Registry No. H-11119

Descriptive Report to Accompany Hydrographic Survey H11119

Project OPR-O112-RA-04

Approaches to Sitka, AK

Figure 1. H11119 Survey Limits and Junctions

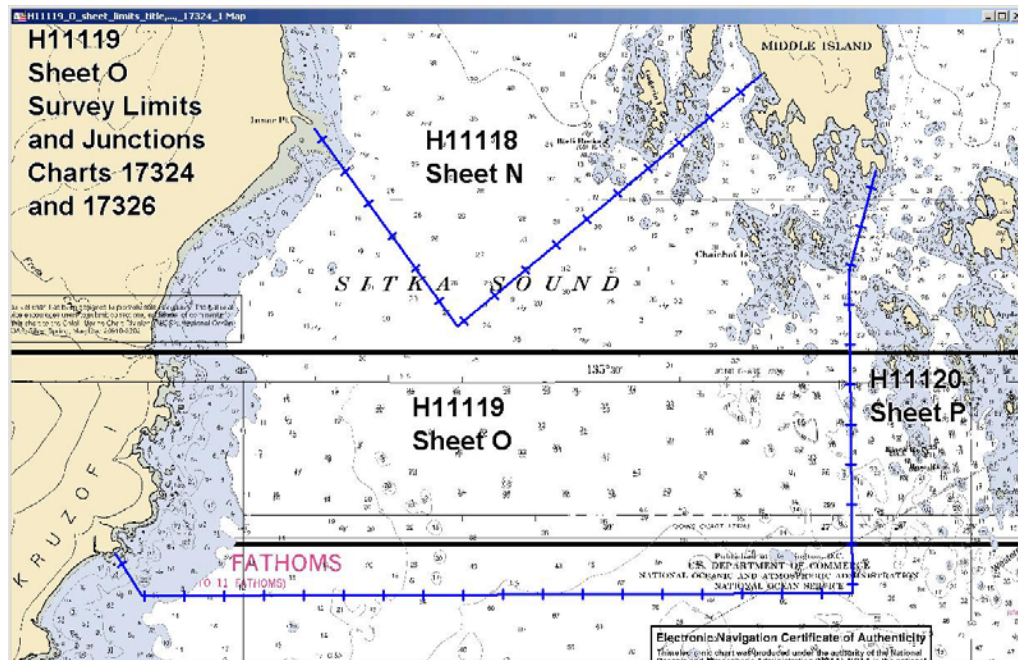
Junctions ⁹

The following contemporary surveys junctions with H11119.

<u>Registry #</u>	<u>Scale</u>	<u>Date</u>	<u>Junction side</u>
H11118	1:10,000	2004	North
H11120	1:10,000	2003	East

A cursory comparison indicates differences are less than 1.8 meters. Final comparisons will be made at the Pacific Hydrographic Branch (PHB) after the application of smooth tides. ¹⁰

- ⁸ Concur, see Review of Hydrographic Survey H11119, dated May 25, 2005, filed with the survey data.
- ⁹ The junction with surveys H11118 and H11120 is complete. A "Joins" note has been added to the smooth sheet in the junction area. Survey H11119 also junctions with surveys H11130 (2004), H11271 (2005) and H11354 (2004). Survey H11130 has been processed and sent to N/CS35. The other two surveys, H11271 and H11354 are in office processing. The junctions between these three surveys is incomplete, therefore, an Adjoins note has been added to the smooth sheet in the appropriate areas.

- ¹⁰ Results of the comparison after applications of approved tides are considered good.
- ¹¹ Approved tide note dated April 13, 2005 is attached.
- ¹² Filed with the hydrographic records.

Figure 9. CFF foul removed

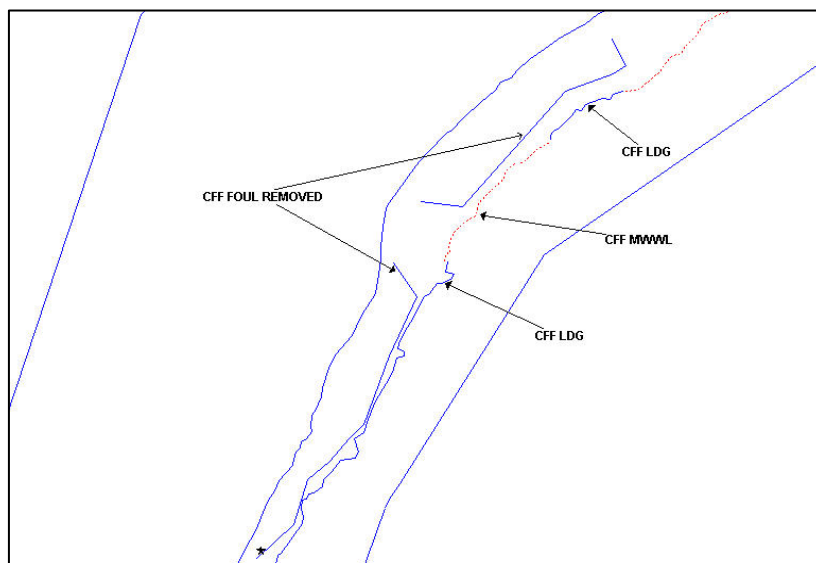
Charted (17324) foul and CFF foul between 57°04'56.35" N 135°35'04.77" W ; (464561.92 , 6326701.24) and 57°04'06.66" N 135°36'14.03" W ; (463382.32 , 6325174.82) was removed due to foul limits being on top of CFF ledge(see Figure 9).²¹

- ²¹ Concur
- ²² Attached to this report
- ²³ Filed with the hydrographic data
- ²⁴ Concur
- ²⁵ Concur
- ²⁶ and features
- ²⁷ Concur
